# City of Corpus Christi

### Planning Commission

Wednesday, August 10, 2022

**TECHNICAL REVIEW PLAT REQUIREMENTS  
REGULAR PLANNING COMMISSION MEETING  
August 10, 2022**

# Waiver Request for Deviation from the Standard One Way Cycle Track (both sides) Street

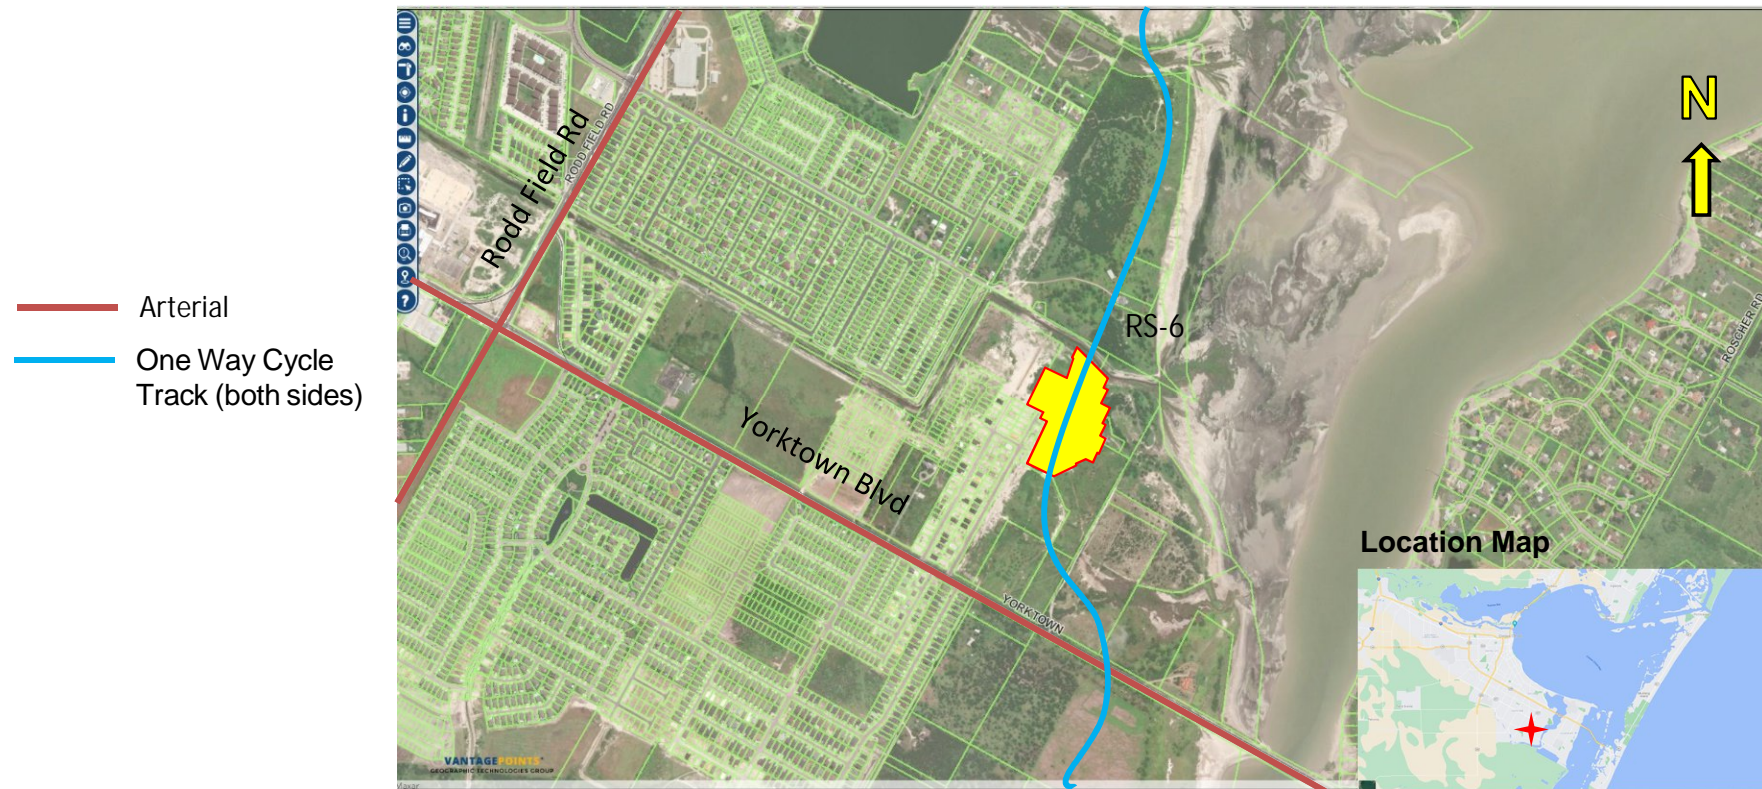
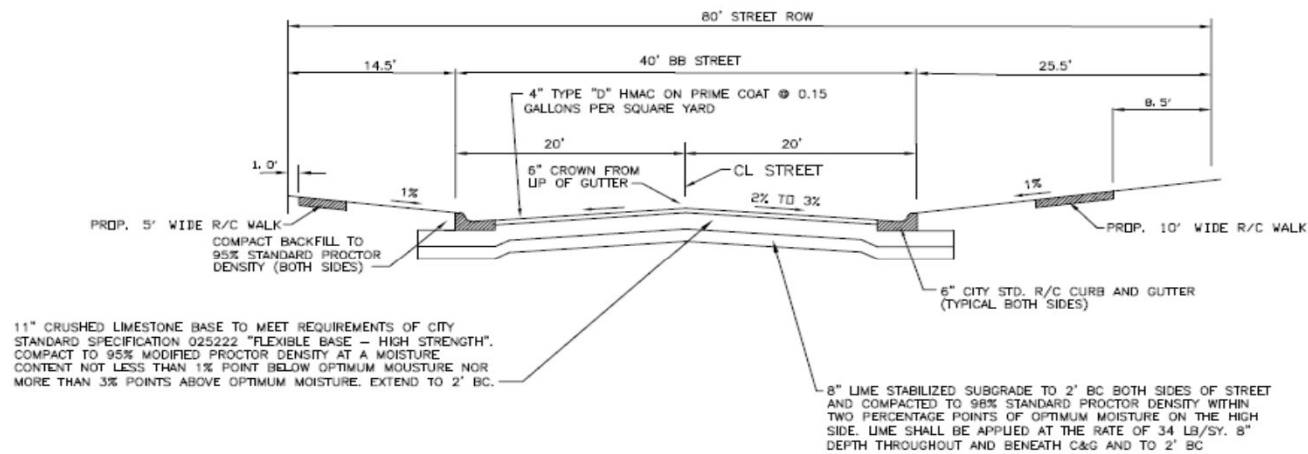
The sidewalk and bike track waiver are for a 675-foot segment fronting Laguna Shores Road and for a 205-foot segment fronting Yorktown Boulevard. Laguna Shores is on the ADA, a Bike Corridor recommended on the Bicycle Mobility Plan and a Parkway Street (P-1) on the Transportation Plan. Yorktown Boulevard is on the ADA Plan, a 1-way, cycle track (both sides) on the Bicycle Mobility Plan, and is a Collector Street (C-2) on the Transportation Plan.

1. Laguna Shores Road and Yorktown Boulevard are on the ADA Plan, the bike Mobility Plan and the Transportation Plan and does not meet the exemption for a sidewalk waiver under UDC 8.2.2.C.5.ii.
2. The 10-ft ROW dedication is necessary in order to meet the 80-ft ROW width for a Parkway Collector (P1). Currently Laguna Shores ROW is 30 feet from the center of the street and the 10-ft ROW dedication will meet their corresponding 40 feet.

After discussion concluded, the public hearing was opened. Engineer of record for the project, Murray Bass with Bass & Welsh Engineering, addressed the Commission in support of the waiver request. He said the ROW dedication will have adverse affects on the property; there is not much room left after dedication and will move setbacks further. He believes the owner may have an additional expense to remove a fence along the ROW line and replacement. Owner of the subject property, Cooper Lundquist, addressed the Commission in support of the waiver request. He concurred with Mr. Bass on the reduction of space and said he would lose approximately 20 to 30 pad sites for the RV park; will cause a loss of revenue which impacts the project as viable. Also, additional expenses will be incurred since they planned to connect to existing utilities for the RV hookups, But if they are required to dedicate, being displaced by 10-feet may require installment of new utility connections.

# Waiver request for an Off-Road Multi-Use Trail and One Way Cycle Track Construction

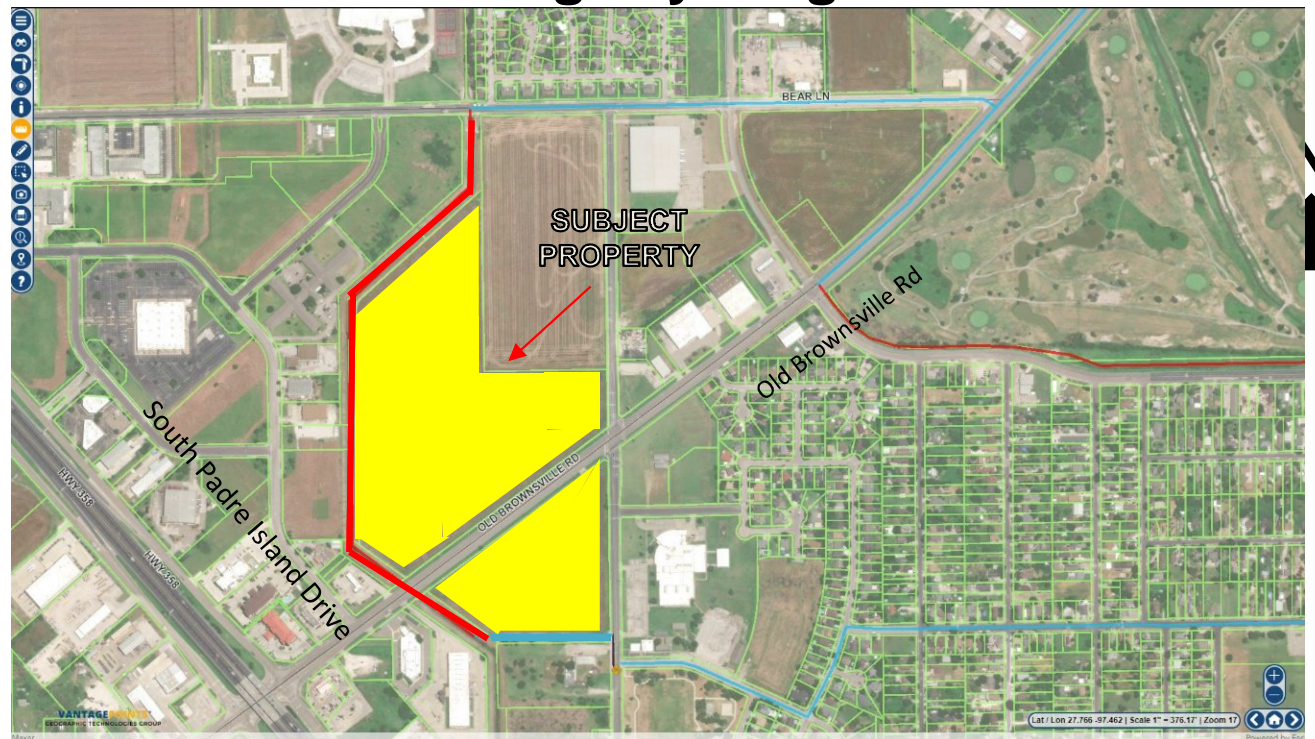
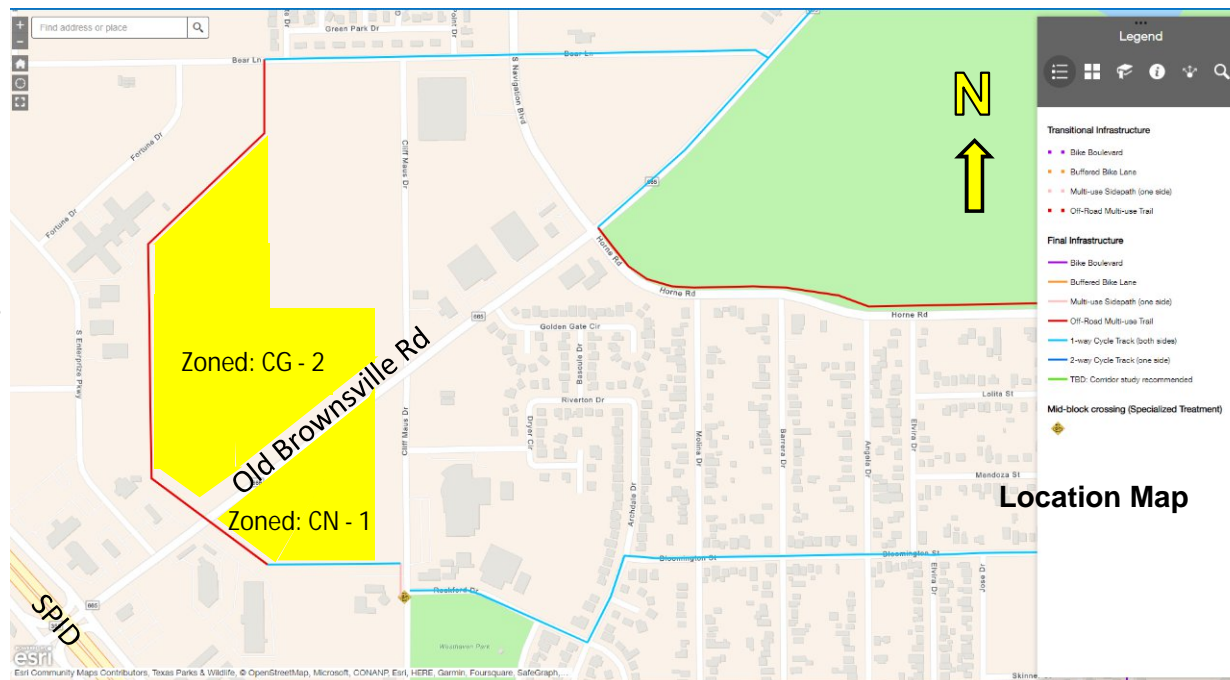
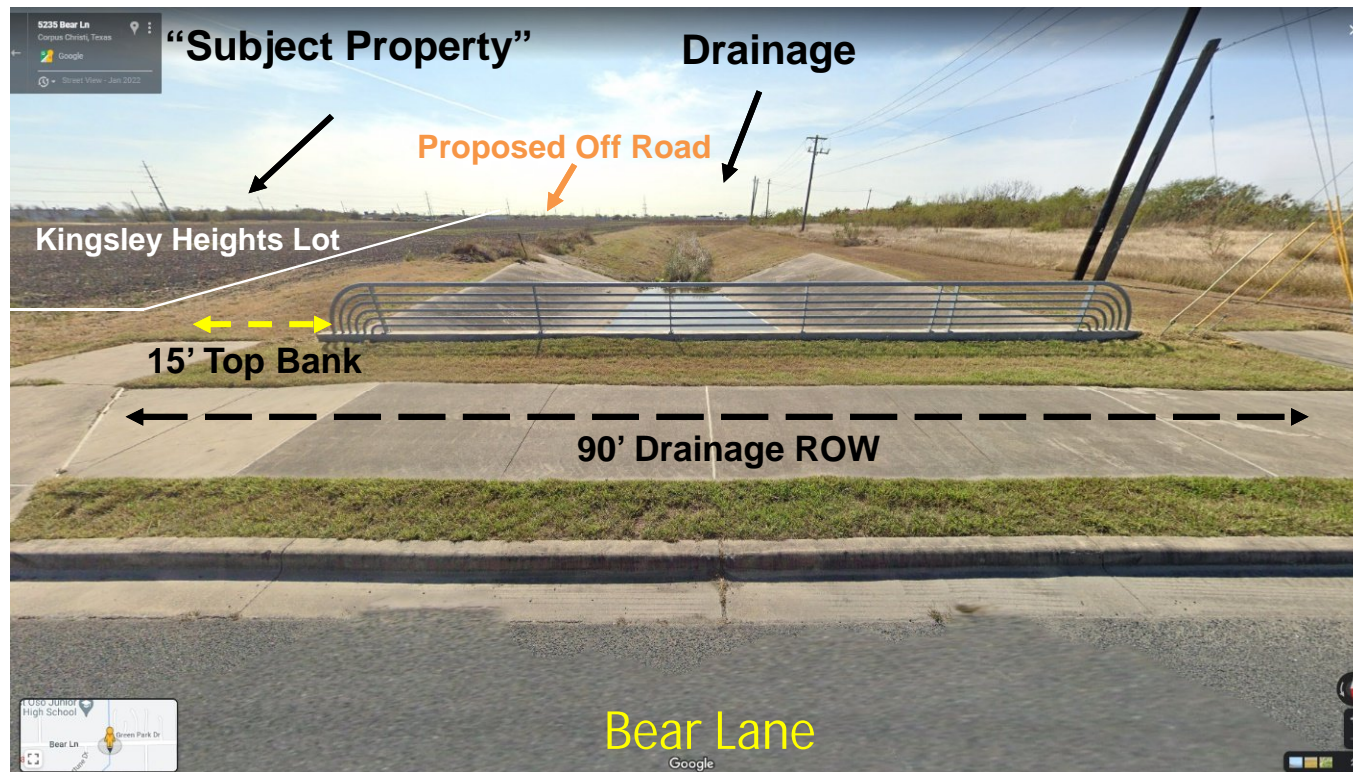
4. There are two bus stops on Bear Lane which support pedestrian and bicycle intermodal connections in close proximity to the Off-Road Multi-Use trail. One bus stop in front of West Oso High School is approximately 371 feet from the proposed off-road multi-use trail and another is 1000 feet to the east of the proposed trail. Each of these stops has 11-17 daily boardings. A third bus stop on Old Brownsville Road is 472 feet from the proposed trail which has 18 – 33 daily boardings.
1. The southern section of the drainage ditch top bank width near Old Brownsville Road. is wide enough to permit the building of the Off-Road Multi-Use Trail. The northern section may necessitate additional access easement. Fifteen feet top of bank would be

6. Rockford Dr. (a paper street with utilities) is 50 ft. in width by 600 ft in length and would need to be constructed with the final plat in Phase II of the development. This would require additional dedication of 12 feet of ROW to accommodate the One-Way Cycle Track. The street segment is short and dead ends at the drainage. Staff recommends, in lieu of construction of Rockford Dr. and the One-Way Cycle Track, that the Off-Road Multi-Use Trail be continued within the Rockford Dr. ROW to connect the trail along the ditch to Claud Maus Dr. This would result in cost savings in not constructing a full road section yet providing pedestrian/bicycle access meeting the intent of the Mobility Plan.
